H-11236

DESCRIPTIVE REPORT

Type of Survey HYDROGRAPHIC
Field No. OPR-0331-KR
Registry No. H-11236

State ALASKA
General Locality Kasaan Bay
Sublocality Twenty Fathom Bank to Skowl Point

Figure 2.

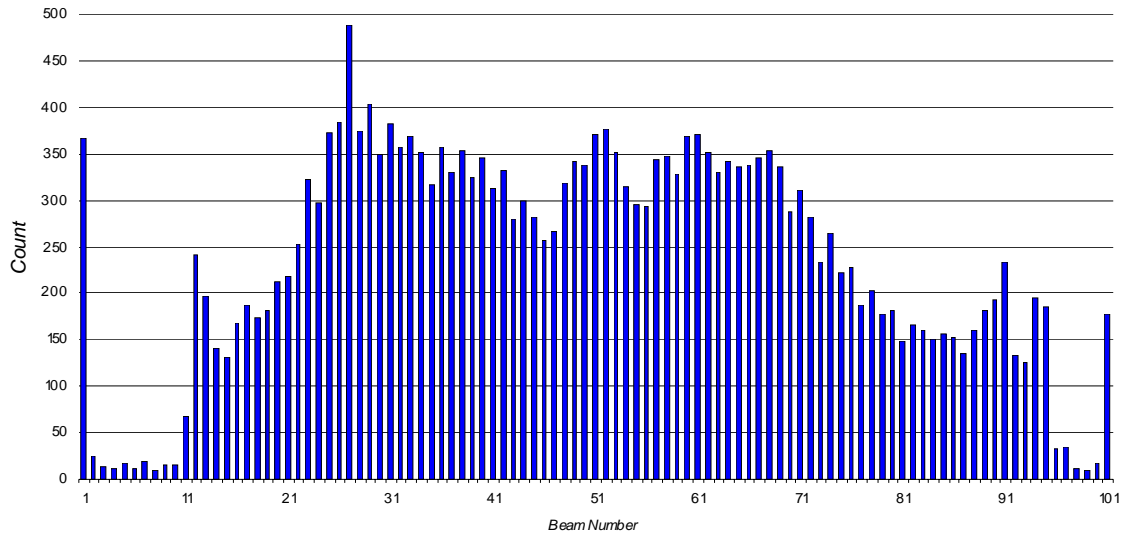
Final smooth sheet soundings were compiled into a spreadsheet and plotted. Figure 2 contains two charts, one showing the distribution of soundings by beam number and depth⁷, and below it a histogram depicting the number of soundings per beam on the smooth sheet. The green line represents the 95% confidence level based on the crossline analysis. Tabular results are presented in Table 1. The Reson 8101 multi-beam echo sounder has 101 beams and is numbered from port to starboard, 1-101 with beam 51 representing the nadir beam.

⁷ Do not concur. The portion of Figure 2 showing the distribution of soundings by beam number and depth is not found in the Descriptive Report.

Figure 3.

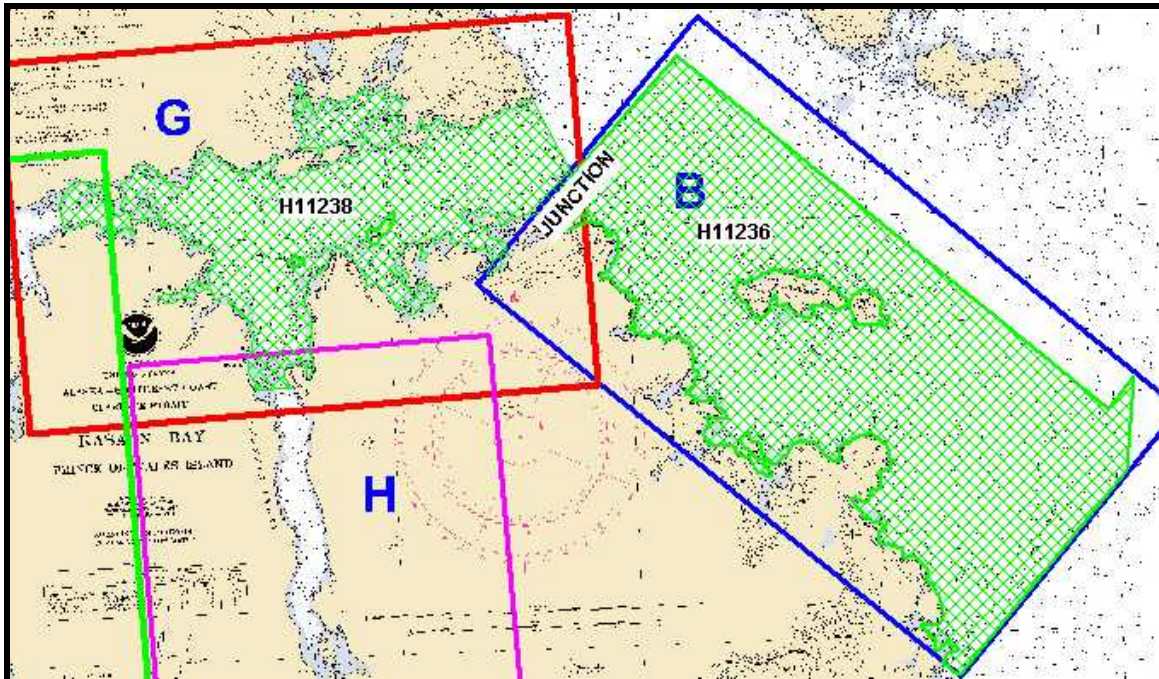
The northwest limits of this survey⁸ junctions⁹ the easterly limits of H11238 (2003, Scale 1:10,000). Both of the smoothsheets for H11236 and H11238 were plotted at the same scale and the soundings for both surveys agreed well.¹⁰ There are no recommendations and no adjustments were made.

¹⁰ Concur. In PHB processing, H11236 was also compared with OPR-0331-KR-02 surveys H11097 and H11098. All junction areas showed very good correlation.

Chart 17426 with new rock positions circled red

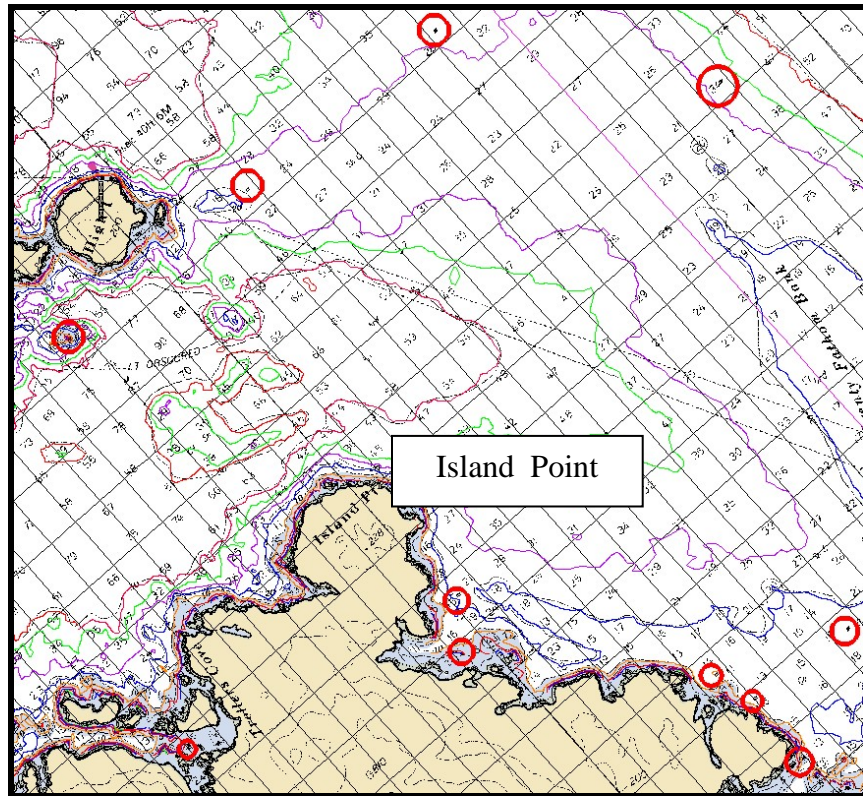
There were 11 new rocks identified in this survey from bathymetry. The following is a list of their positions and depths.²²

Based on the results of survey H-11236, the Hydrographer recommends updating the next editions with the rocks listed.³³

²² Chart features according to the smooth sheet and Hdrawing except as noted.

- ³³ See endnote 22.
- ³⁴ Concur with clarification. One Danger to Navigation Report is included in Appendix A. No associated correspondence is attached. See endnote 58 for further information.

Chart 17426 Location Map³⁷

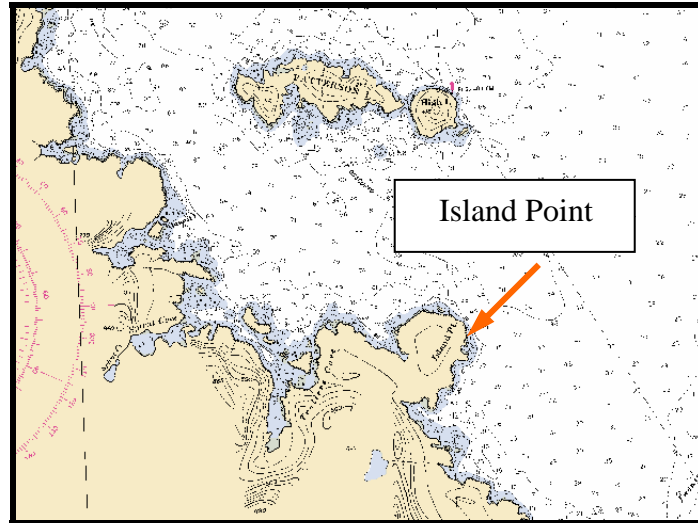
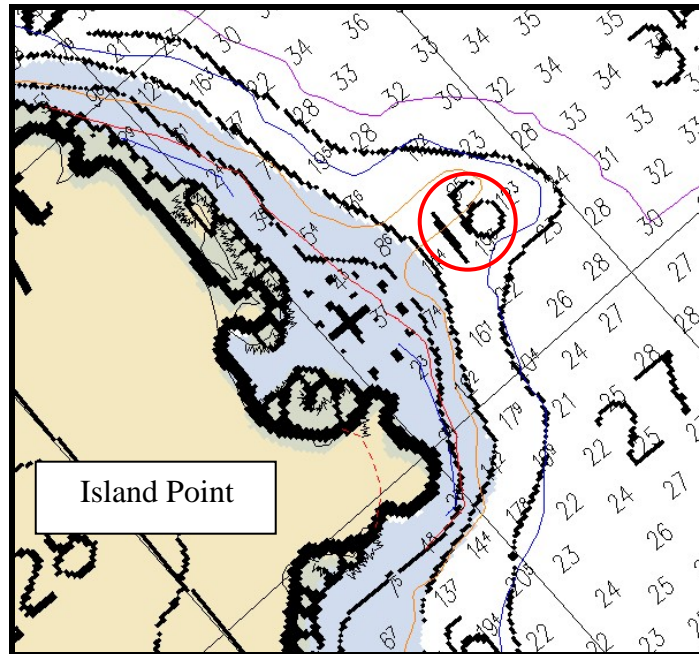
A review of the soundings and chart shows a 9.5-fathom³⁵ near a ³⁶16-fathom sounding.

Based on the results of survey H-11236, the Hydrographer recommends replacing the 16-fathom sounding at 55° 22' 05.561"N and 132° 09' 34.401 "W with a 9.5- fathom sounding.³⁸

- ³⁵ Insert “sounding”.
- ³⁶ Insert “charted.”
- ³⁷ Note that the sounding discussed is southeast of the vicinity to which the arrow points. Chart according to the smooth sheet.

- ³⁸ Concur with clarification. Chart 9 fathom 3 foot sounding at smooth sheet position.
- ³⁹ Chart the following area based on the current survey.
- ⁴⁰ Concur. Update Chart 17420 MHWL with verified RSD.

Chart 17426, Location of 100 fathom curve deepening trend

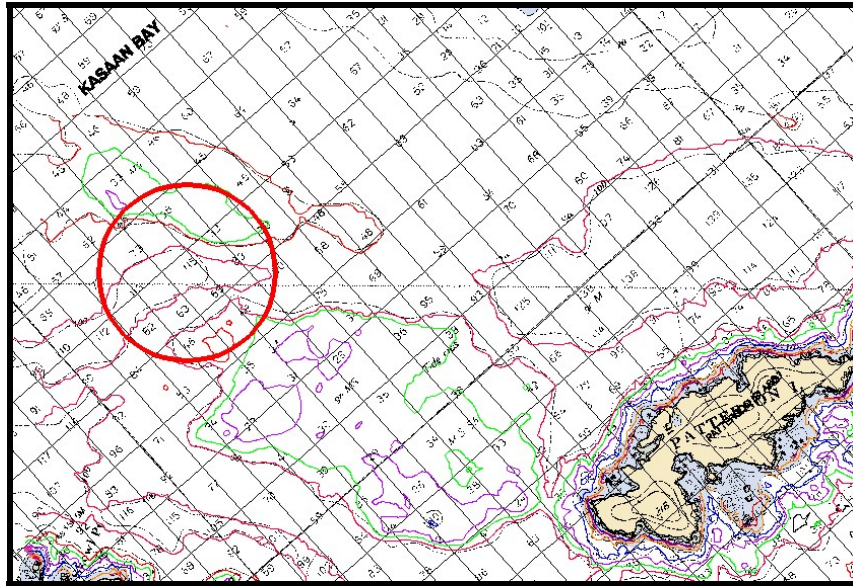
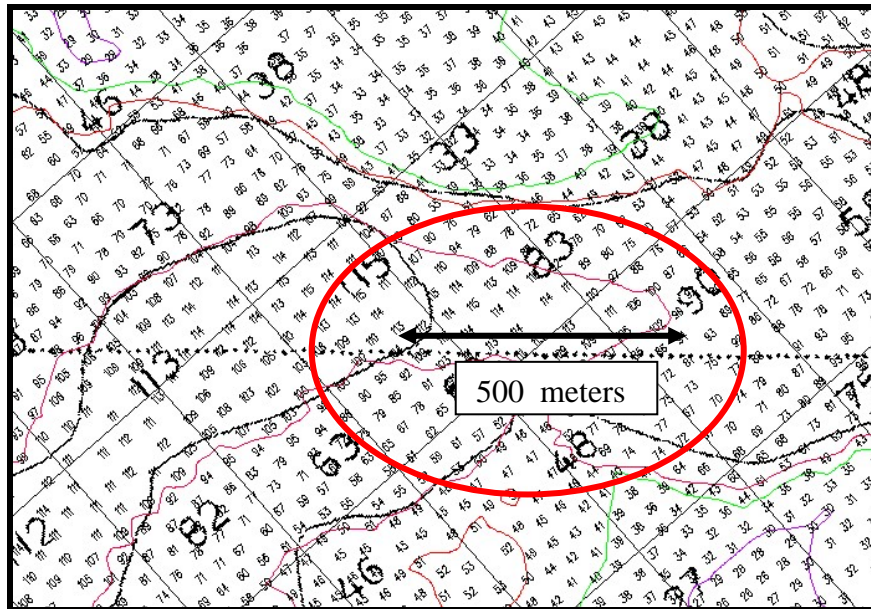
A review of the soundings and chart shows a deepening trend in the circled 100-fathom curve below.³⁹

Based on the results of survey H-11236, the Hydrographer recommends updating the next editions using the 2003 soundings to extend the 100-fathom curve at the above location 500 meters southeast.

Location of shoreline discrepancy (circled) on Chart 17420 with 2003 soundings

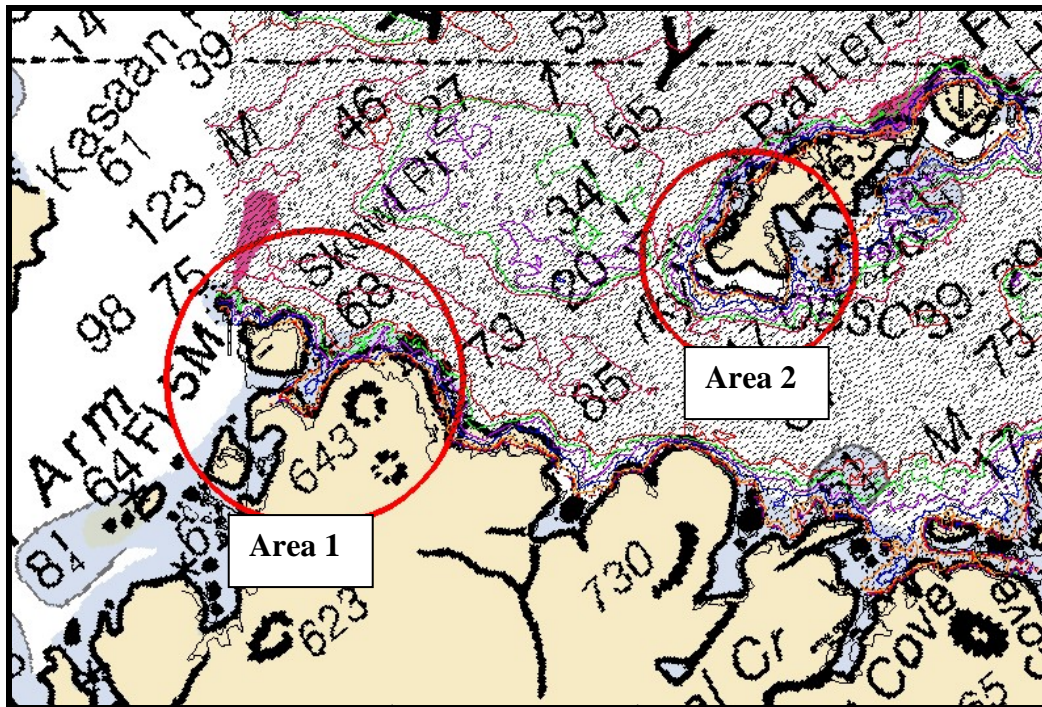
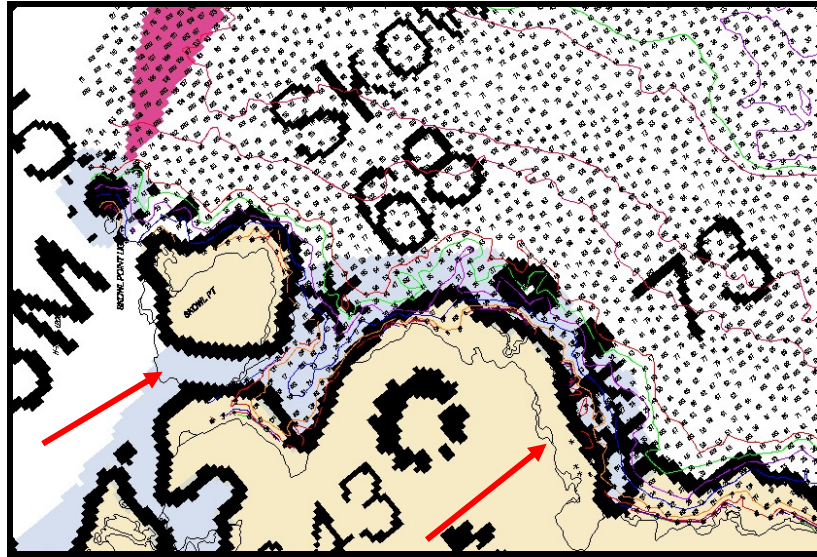
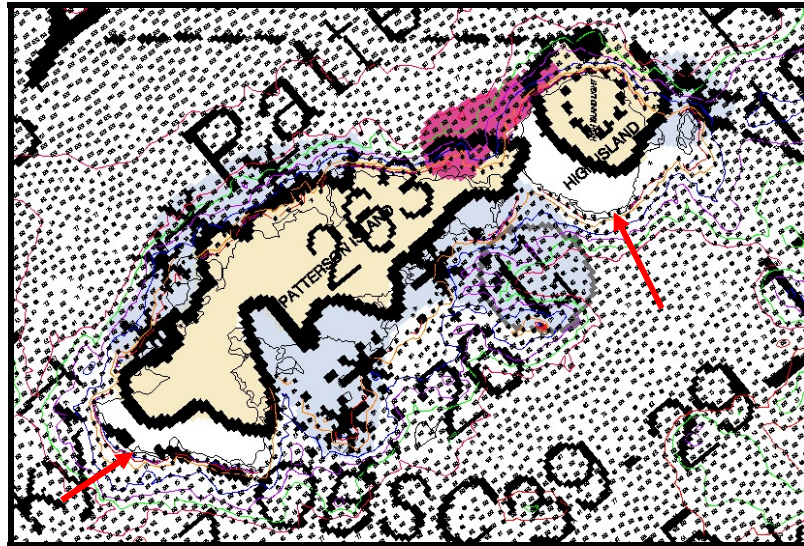
This survey generally agreed well with the chart. There were no outstanding disagreements with the depth curves or soundings. A comparison of the chart and remote sensing data shows a discrepancy of two areas in excess of 200 meters. These areas show the charted shoreline shifted to the east of the remote sensing data. The remote sensing data was verified through traditional and limited methods during this survey and was found to be accurate.⁴⁰

Detail of shoreline change on Chart 17420

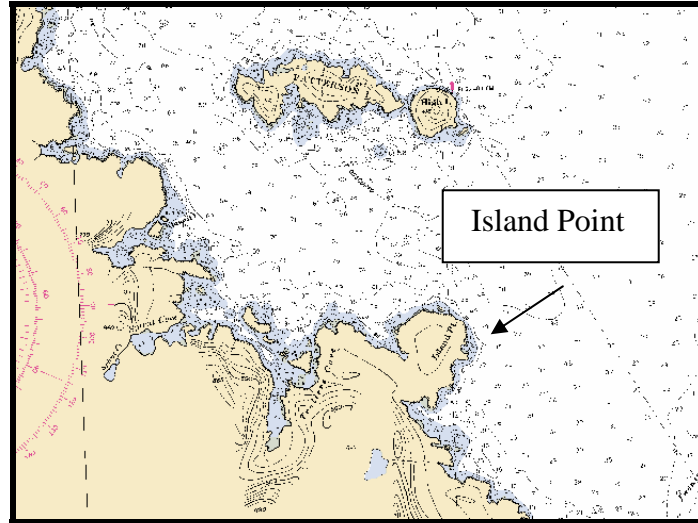
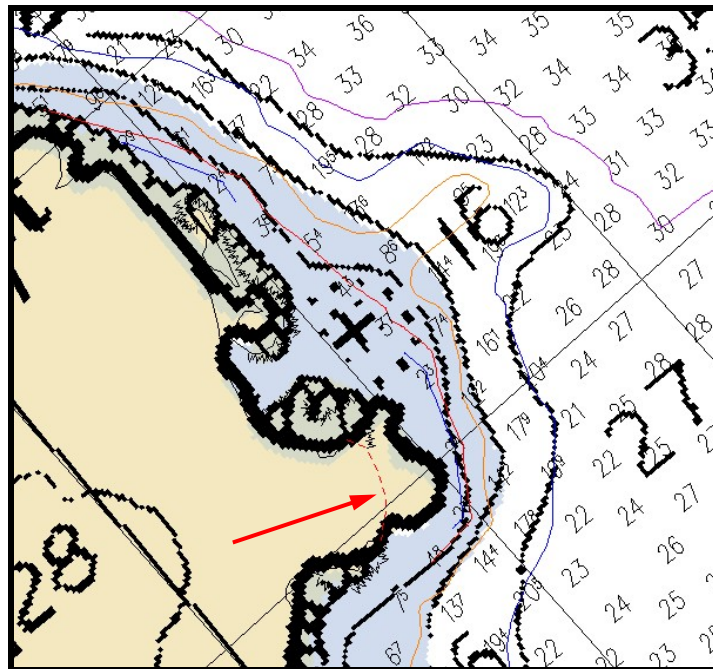
The survey identified a portion of shoreline that did not agree with the chart or the RSD. This was discovered during limited verification and is shown as a dashed red line on the smooth sheet.⁴⁴

- ⁴³ Charted features not shown on the RSD that were noted as PITBI’s were retained on the Hdrawing.
- ⁴⁴ Concur with clarification. The MHWL revision is shown as a dashed red line on Level 1 of the Hdrawing.

Chart 17426 with charted areas (circled red) and not charted (circled blue) areas not represented by the RSD

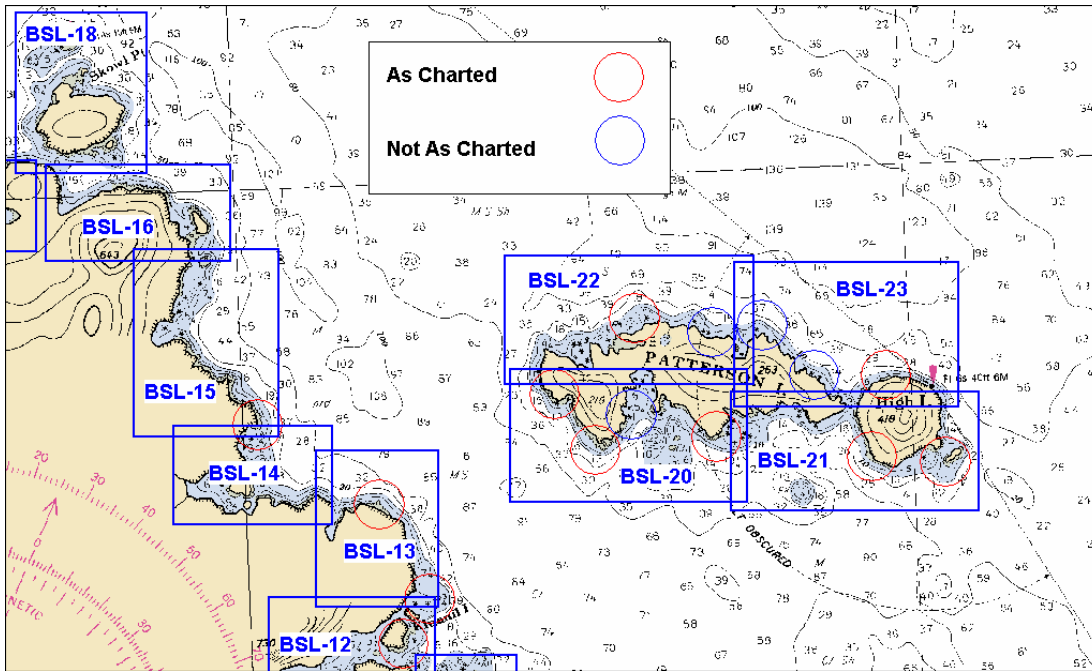
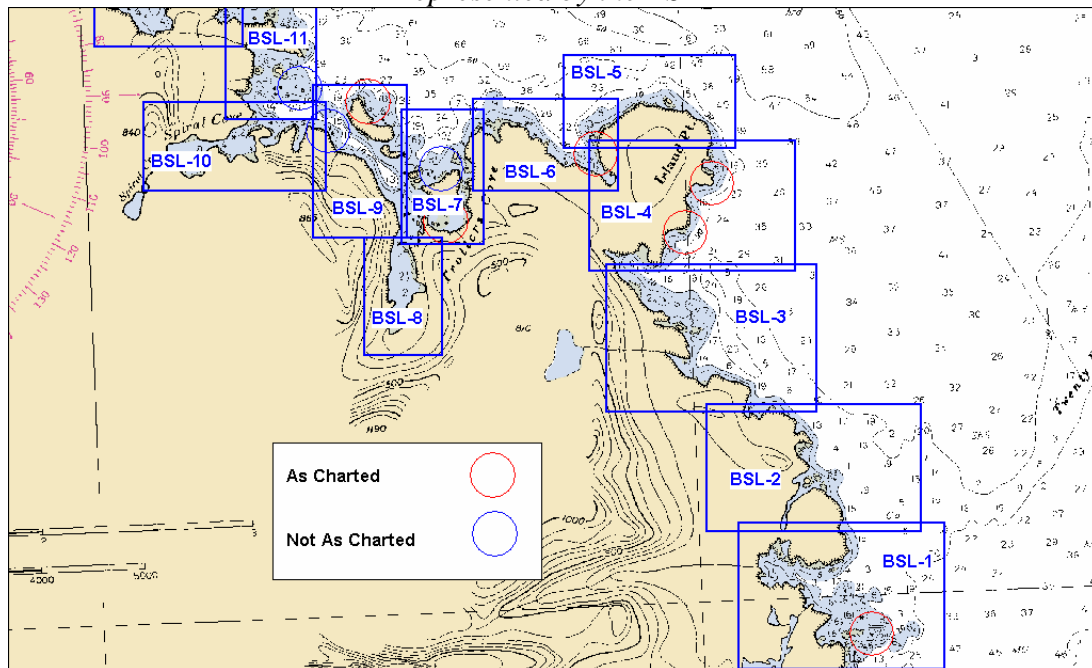
This survey identified foul areas⁴⁵ and ledge lines that were not represented on the RSD. Refer to the images below for location maps of these areas.⁴⁶

Based on the results of survey H-11236, the Hydrographer recommends retaining charted foul and ledge lines not represented by the RSD.⁴⁷ The hydrographer also recommends further investigation into the features not charted that were discovered through shoreline verification.⁴⁸

- ⁴⁵ Foul areas identified on the smooth sheet were depicted on the Hdrawing as scale permitted. Chart according to the Hdrawing.
- ⁴⁶ Note that Shoreline Verification Maps BSL-17 and BSL-19, included in the H11236 Shoreline Verification Field Notes filed with the project reports, fall within the limits of survey H11238, OPR-0331-KR-03.

- ⁴⁷ Concur. Retain area as charted and as depicted on the Hdrawing.
- ⁴⁸ Investigate features as budget and national survey priorities allow.
- ⁴⁹ The evaluator concurs with the hydrographer’s findings except as noted. Heights given in the following table are in meters. Where warranted by scale, rocks have been incorporated into ledges on the Hdrawing. Chart all features according to the smooth sheet and as portrayed on the Hdrawing except as noted.

Detail of Chart 17426 with 2003 soundings

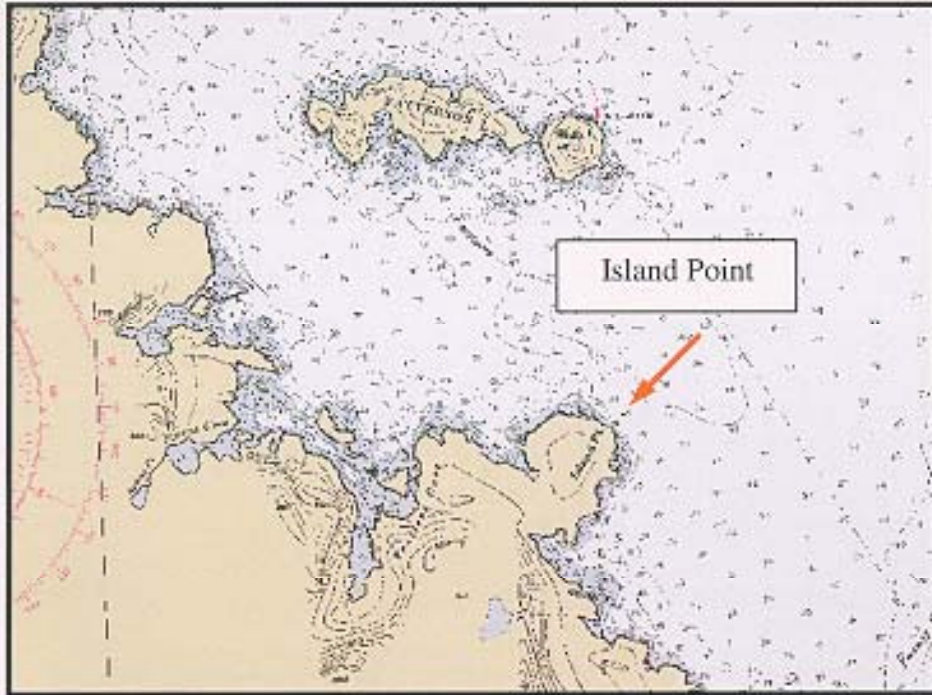
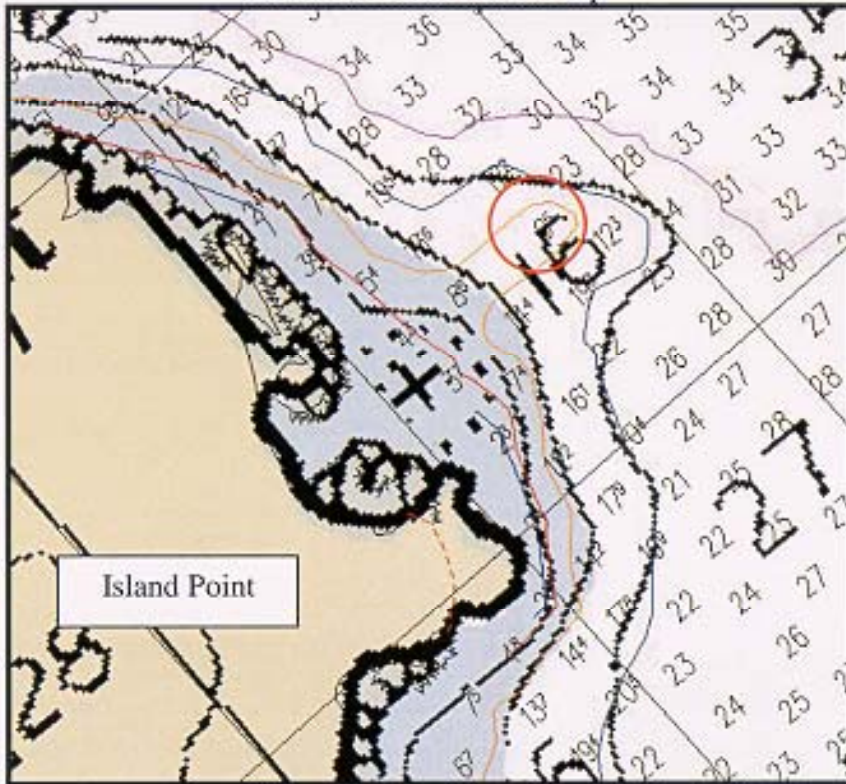
Feature	Depth(ft or fms)	Latitude	Longitude
Sounding	9 fms 3 ft	55° 22' 05.6" N	132° 09' 34.4" W ⁵⁸

⁵⁸ Concur with clarification. Chart 9 fathom 3 foot sounding at smooth sheet position.
